STATE OF HAWAII
DEPARTMENT OF TRANSPORTATION
HIGHWAYS DIVISION

PROJECT NO. I-H2-1(13):4

MILILANI INTERCHANGE

STATE OF HAWAII
 DEPARTMENT OF TRANSPORTATION
 HIGHWAYS DIVISION
 PROJECT NO. I-H2-1(13):4
MILILANI INTERCHANGE
SPRINKLER PLAN
AREA "M-6"
 SHEET No. 9 OF 25 SHEETS

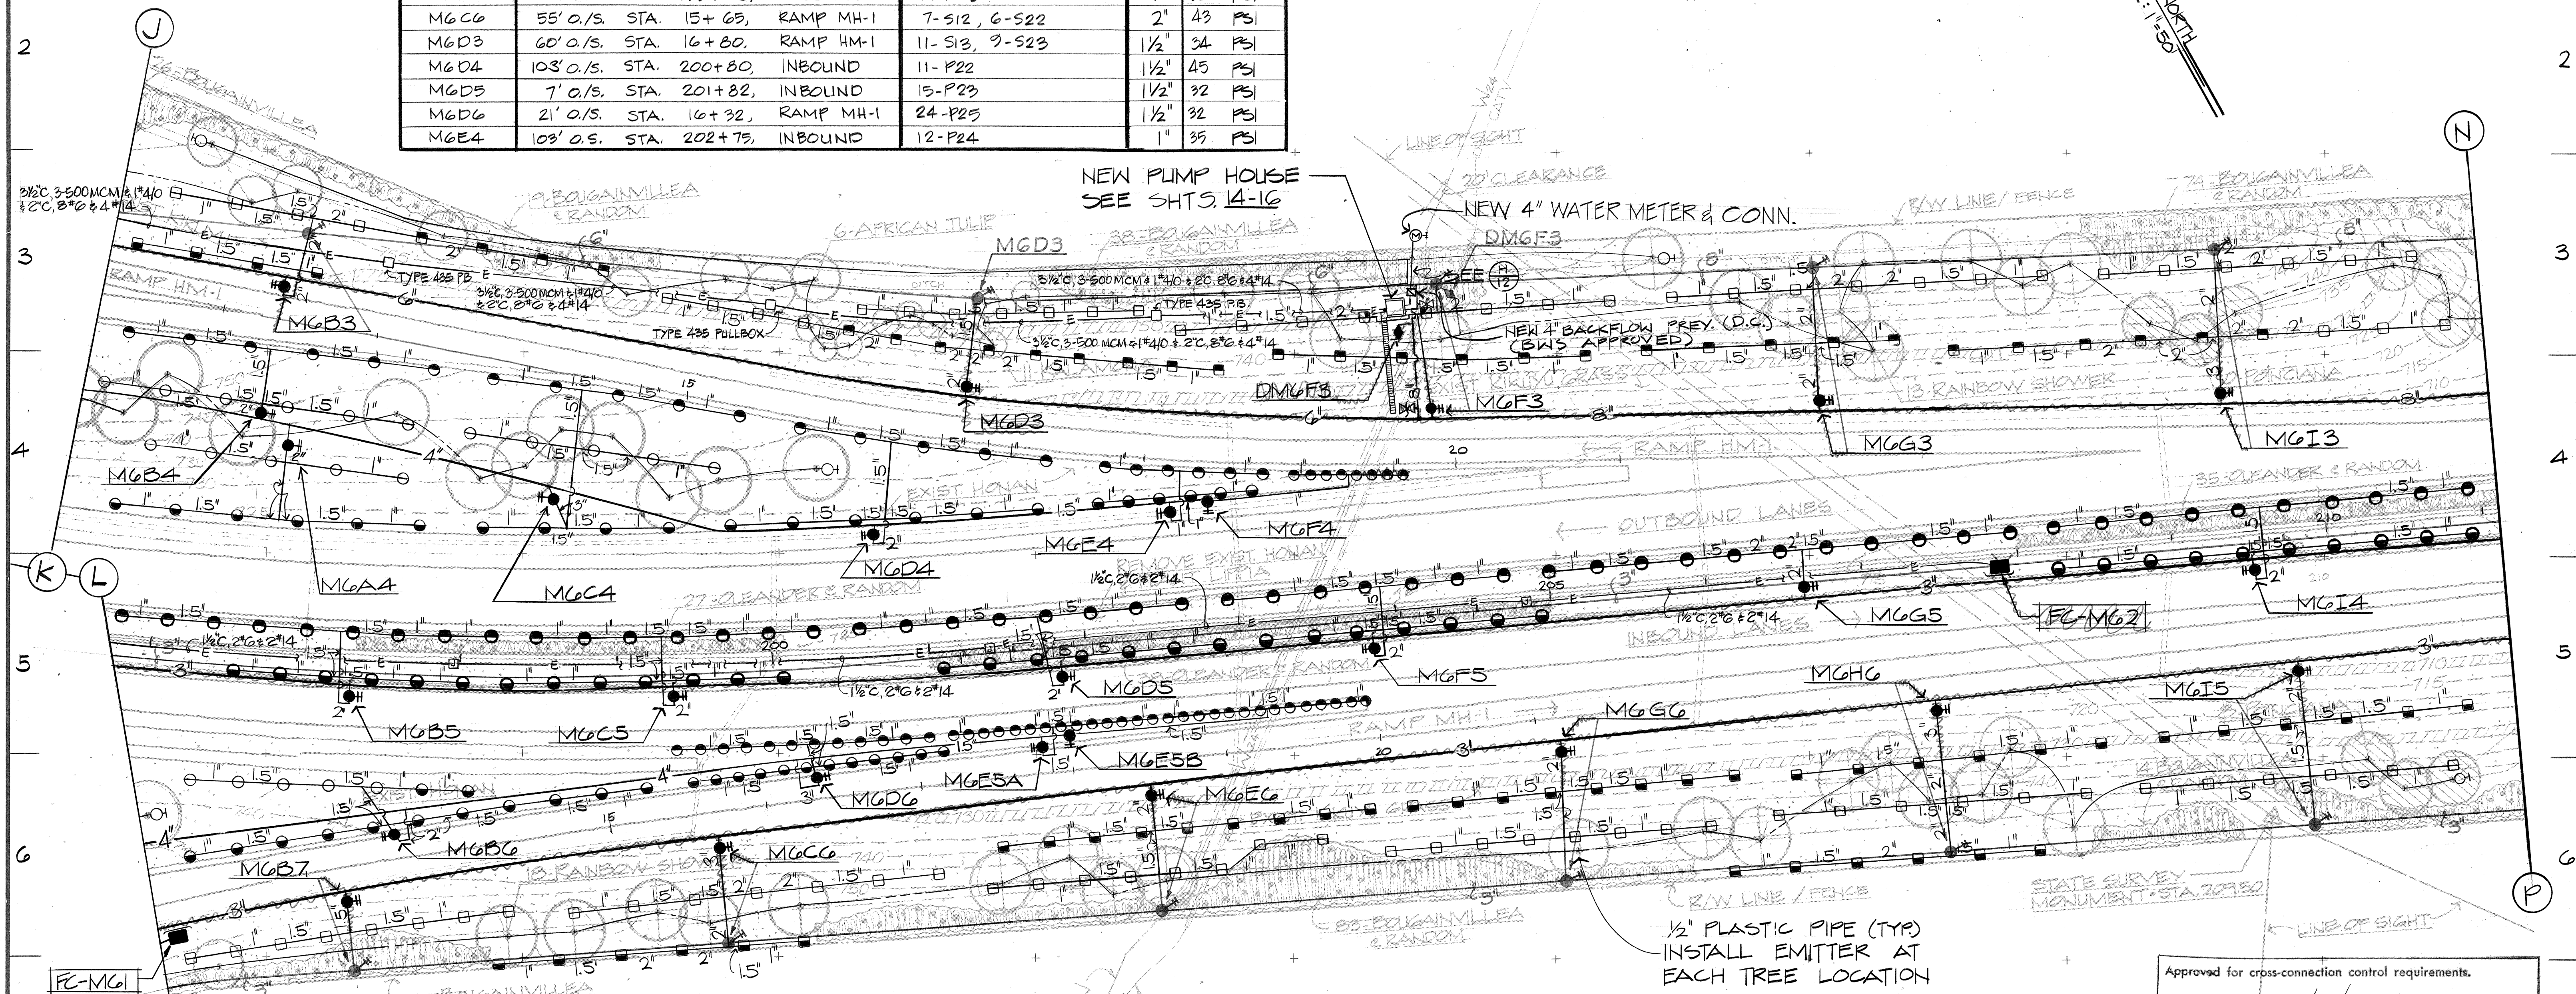
DATE	REVISION
11/17/76	523 Sprinkler Heads in BANK Nos. M6B5, M6C5, M6D5, M6F5, M6G5 & M6I4 replaced with P23 Sprinkler Heads per Addendum No. 1 Reference (A) in grid F3 revised to read (H). Meter and connection in grid F3 revised to read "New 4" WATER METER AND CONNECTION."

STATE OF HAWAII
DEPARTMENT OF TRANSPORTATION
HIGHWAYS DIVISION
PROJECT NO. I-H2-1(13):4
MILILANI INTERCHANGE
SPRINKLER PLAN
AREA "M-7"
SHEET No. 10 OF 25 SHEETS

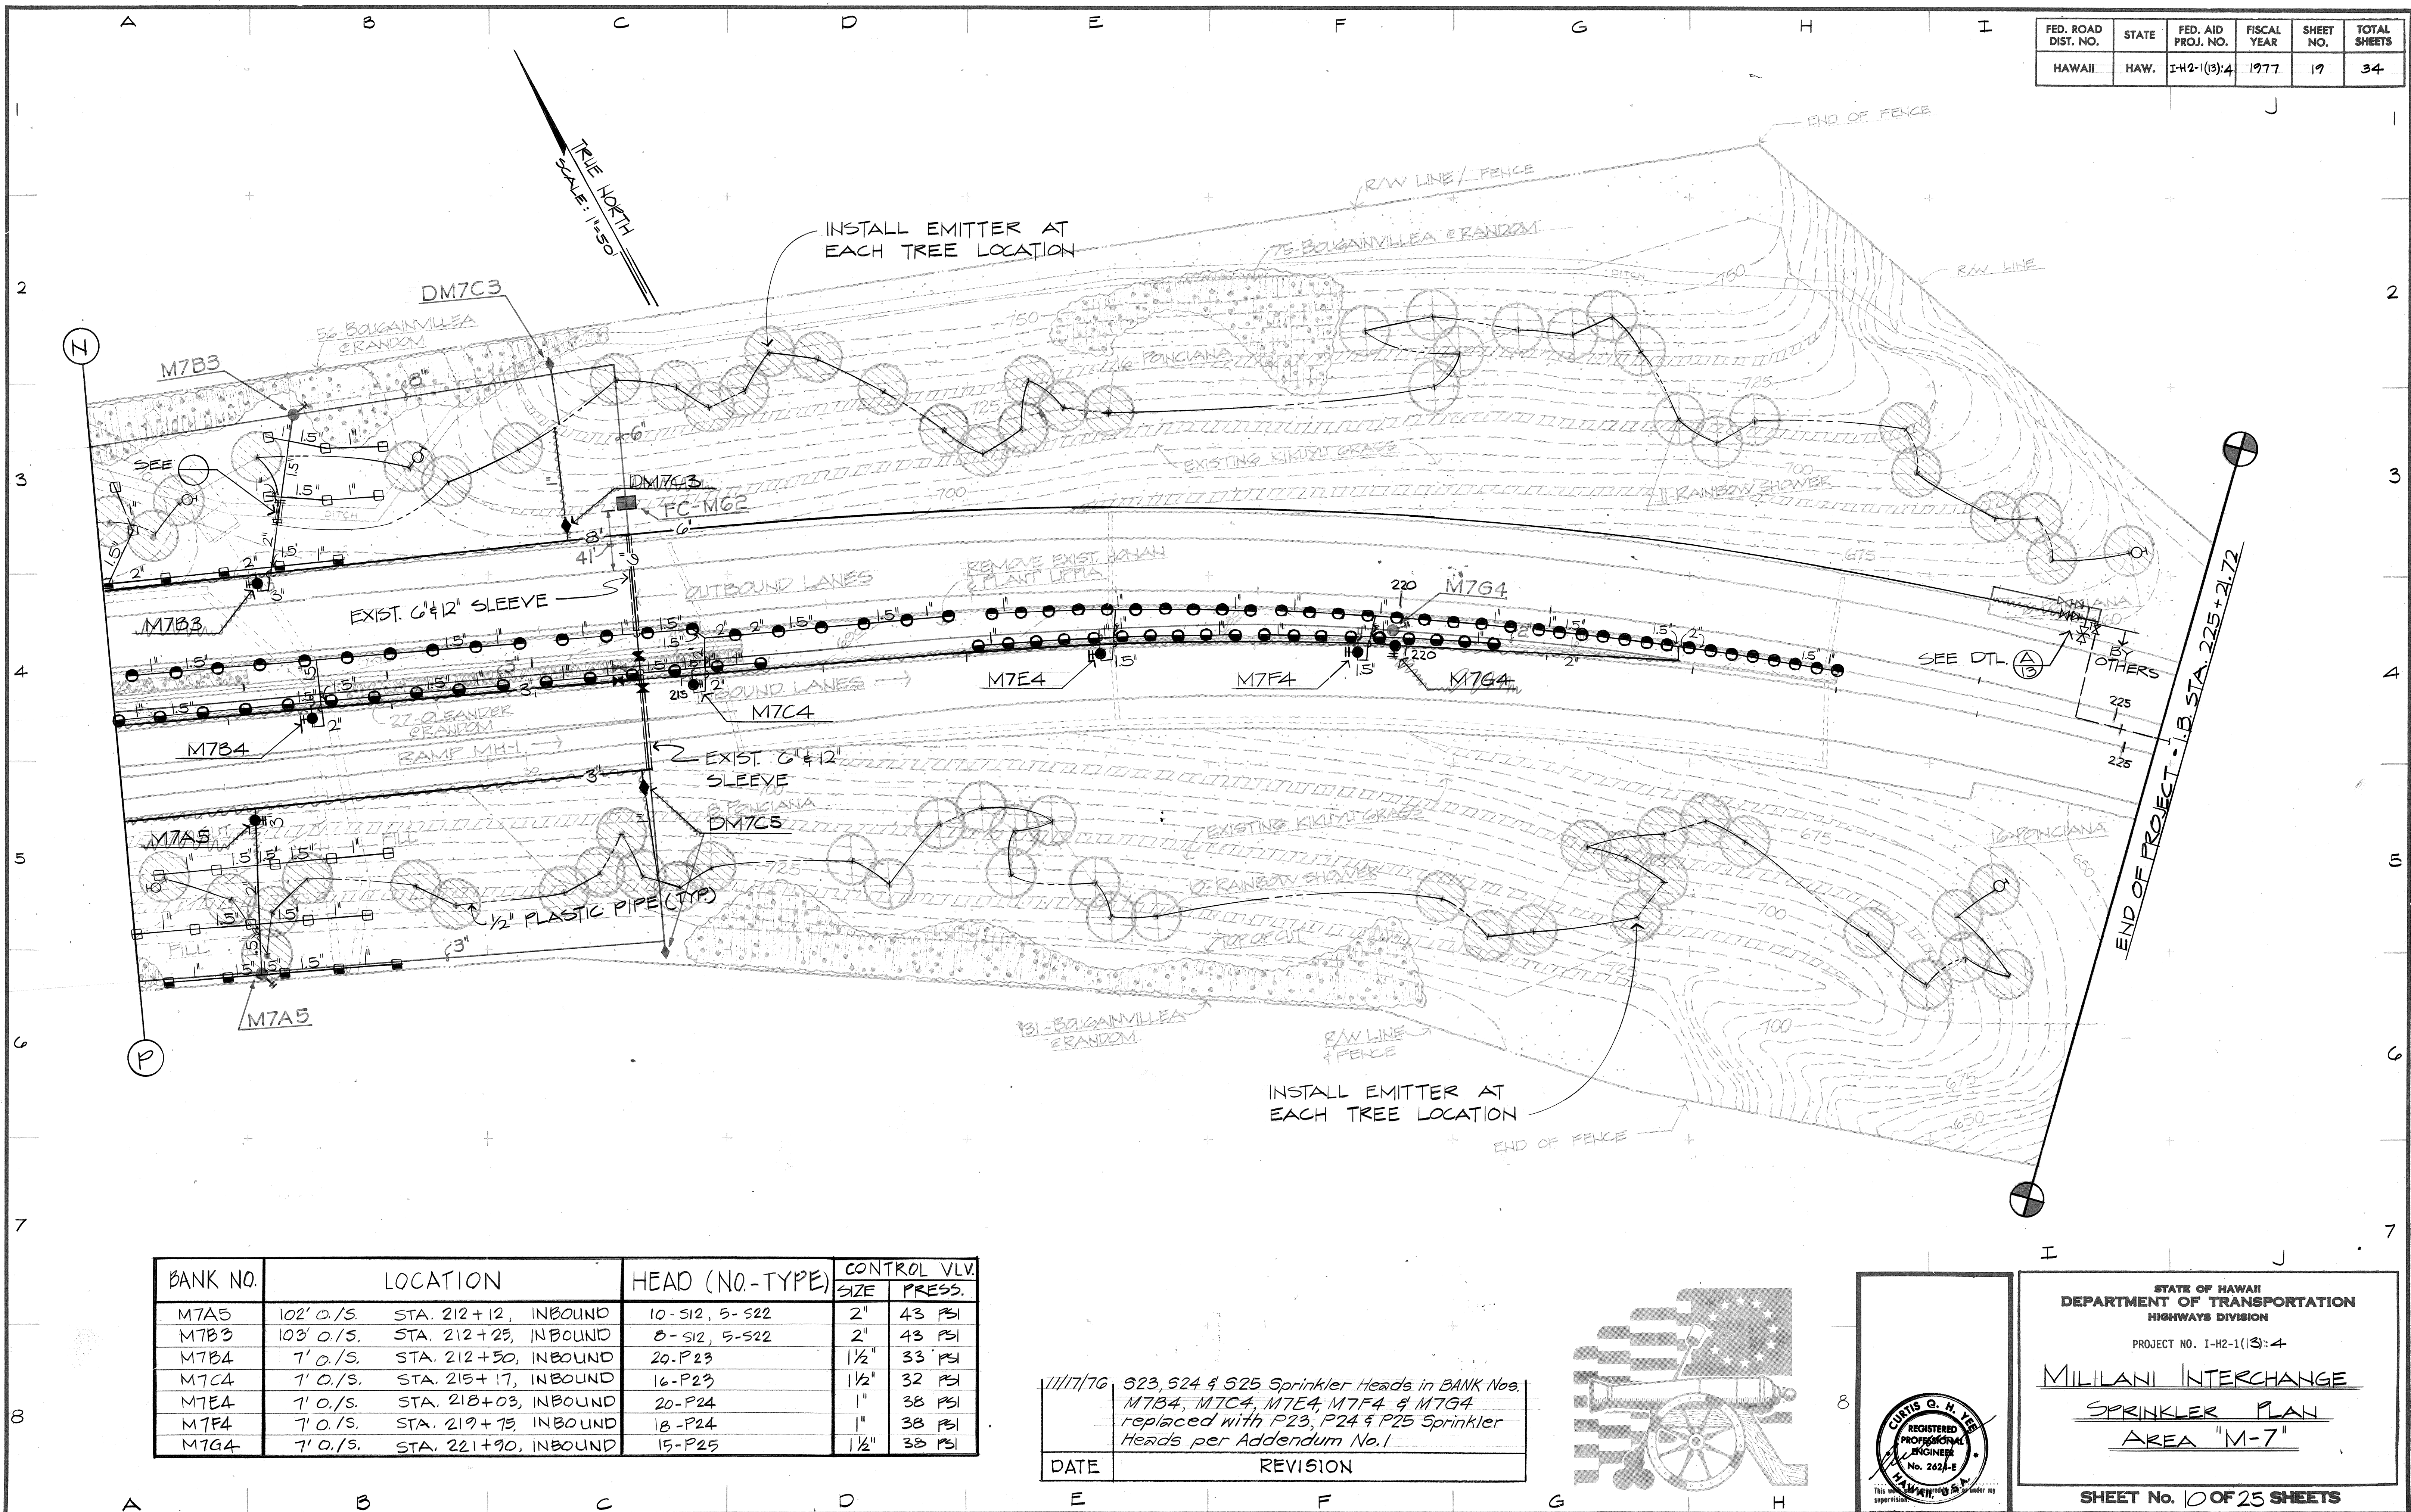
11/17/76	523, 524 & 525 Sprinkler Heads in BANK Nos. M7B4, M7C4, M7E4, M7F4 & M7G4 replaced with P23, P24 & P25 Sprinkler Heads per Addendum No.1
DATE	REVISION

D AUTO. SPRINKLER CONTROL VALVE
N.T.S.

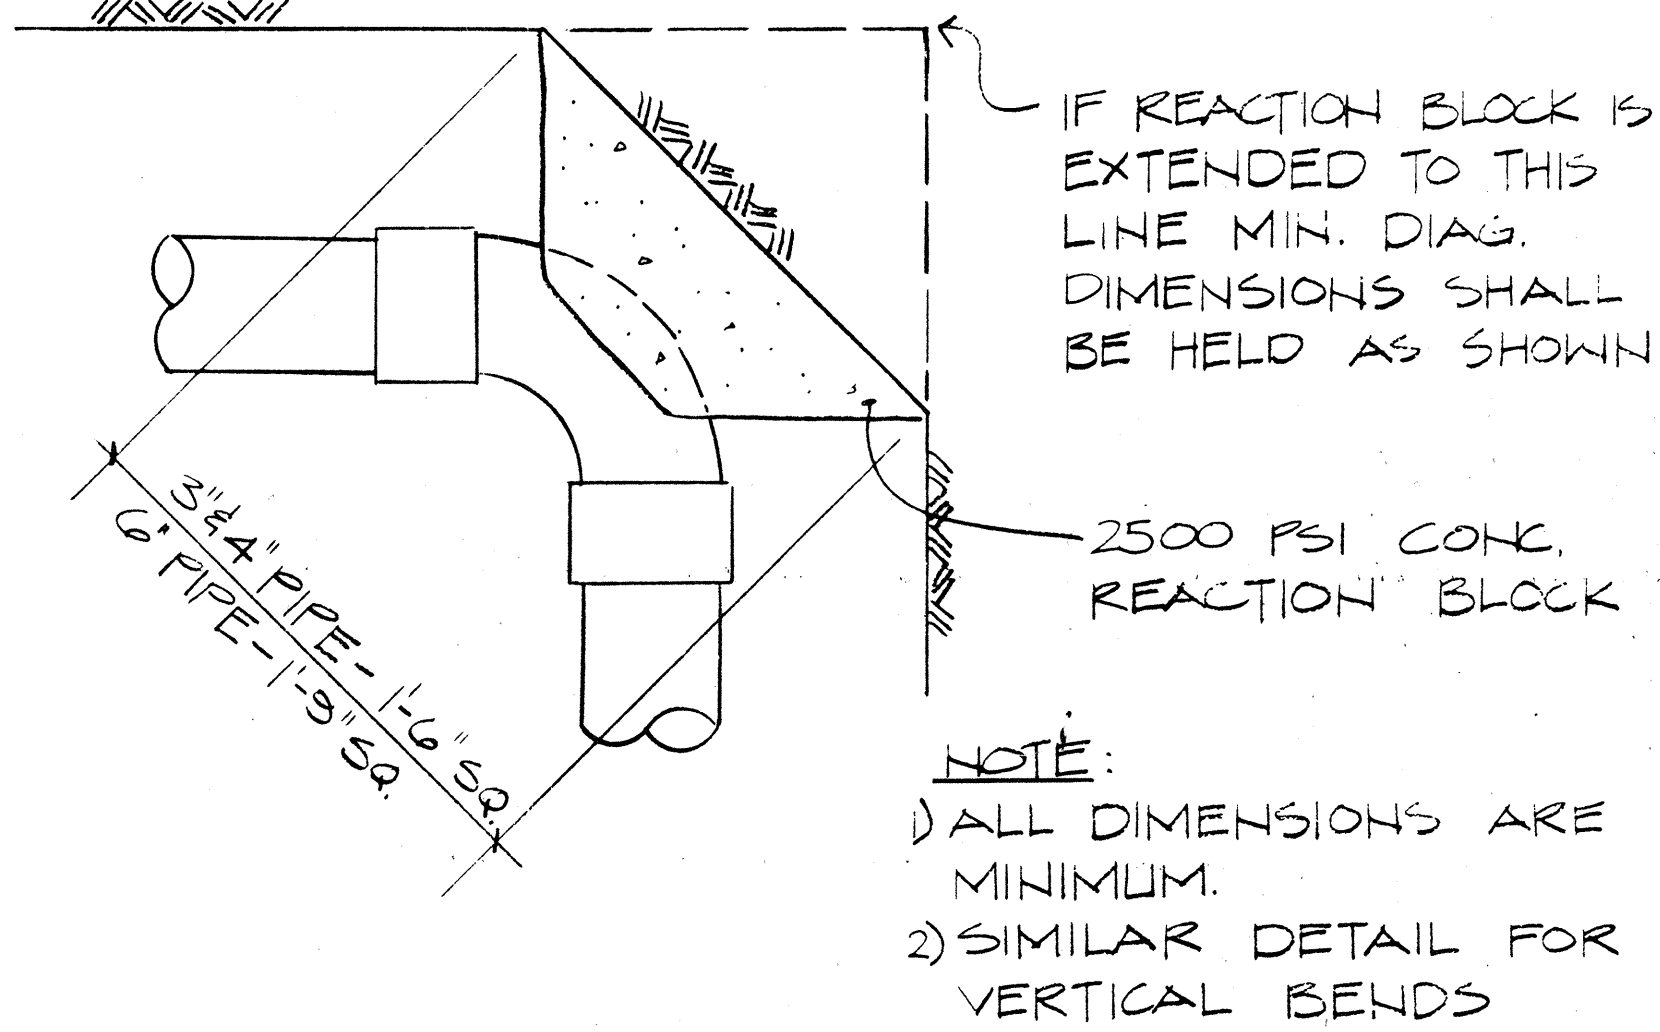
11/17/76	Revised terminology and title of value for Detail
DATE	REVISION

(Y) 14 INTERIOR ELEVATION "Y"
SCALE: 1/2" = 1'-0"

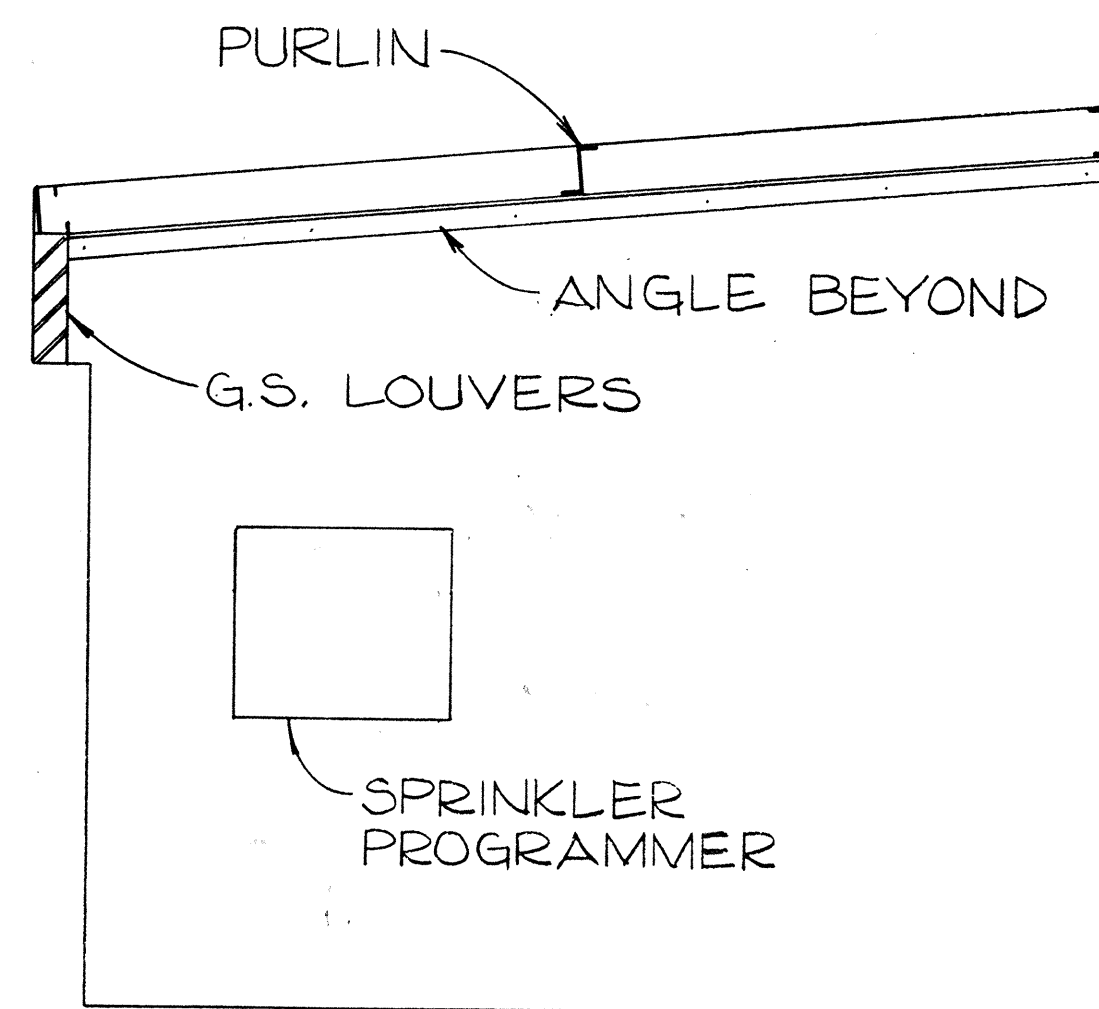
11/17/76 On Detail (Y) deleted part of reference to Flow Indicating Gauge per Addendum No. 1.

F DETAIL
N.T.S.

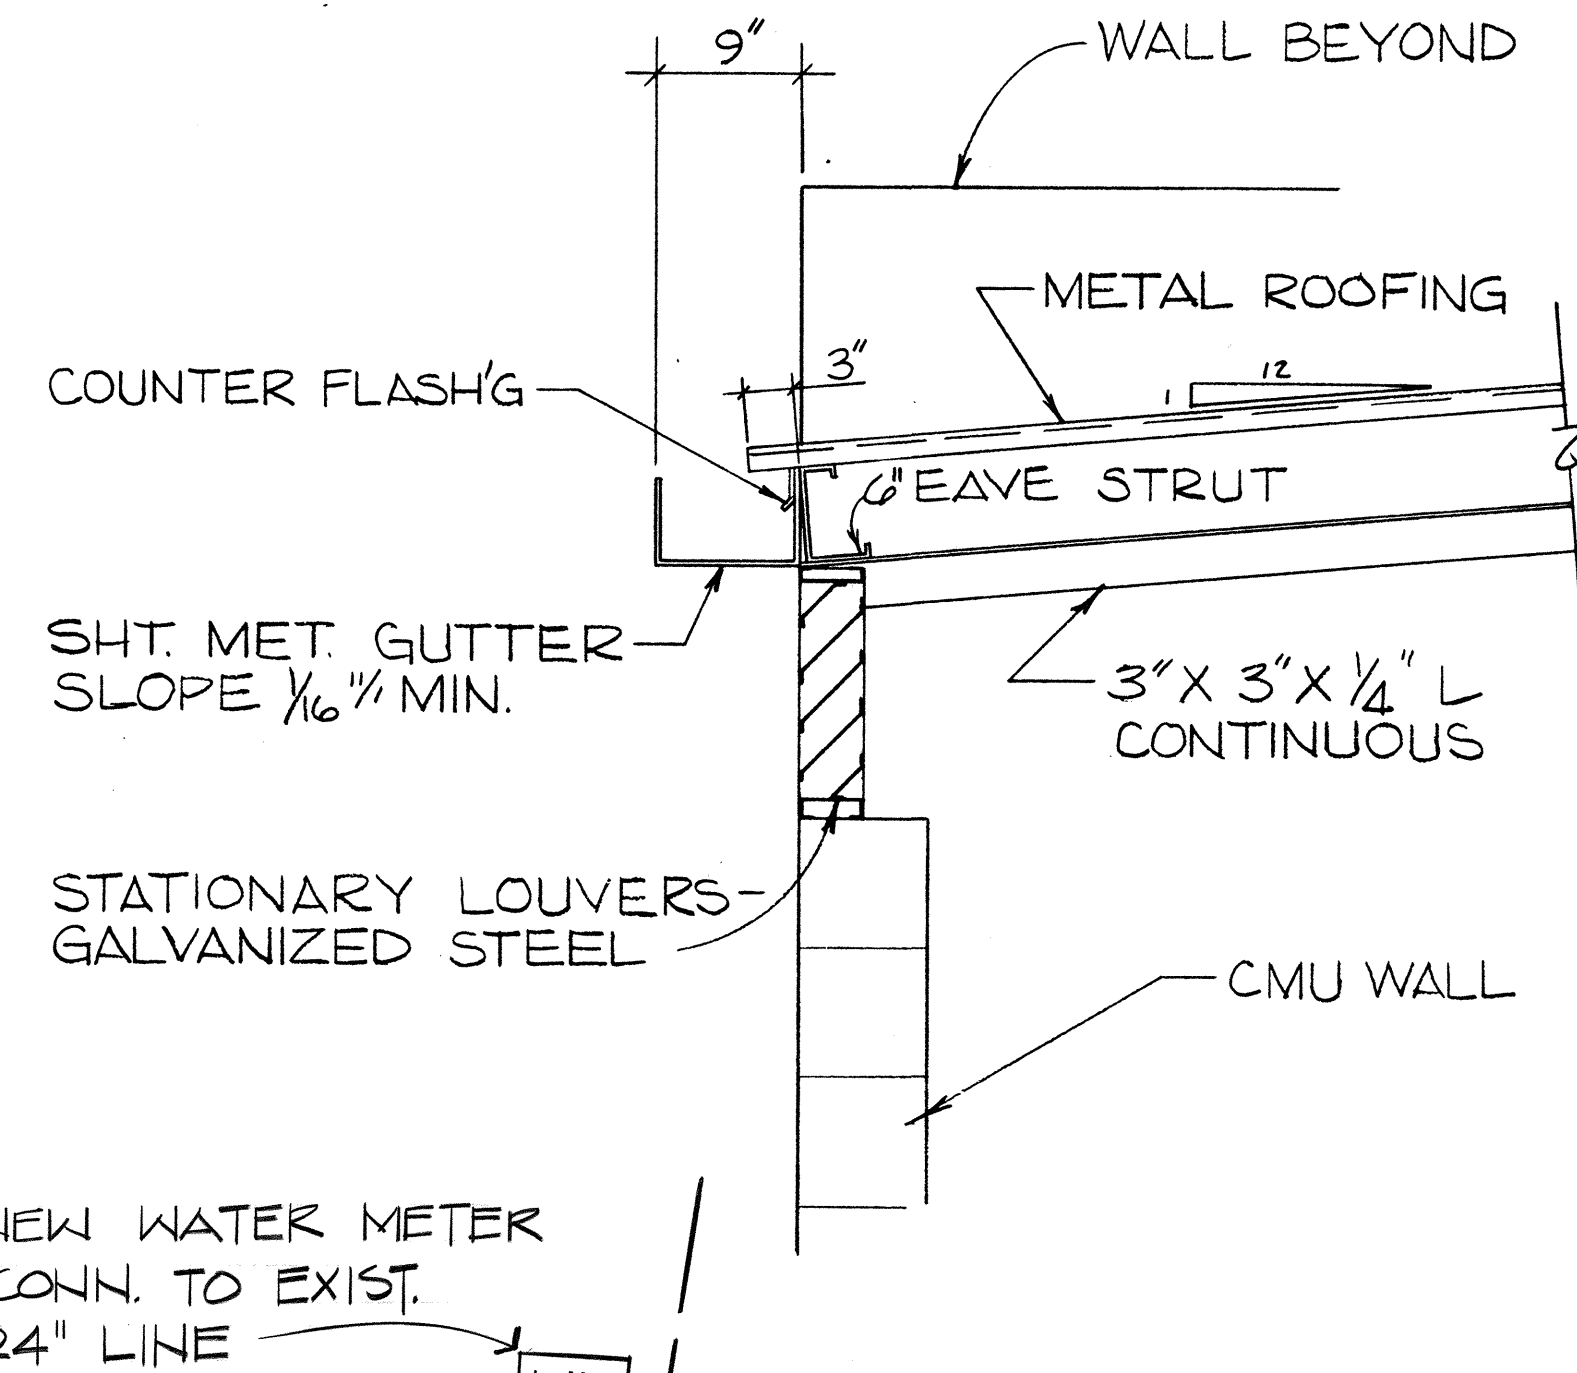
DATE	11/17/76
REVISION	Pipe Support reference circle on Detail (F) 16 to read (F) 16.
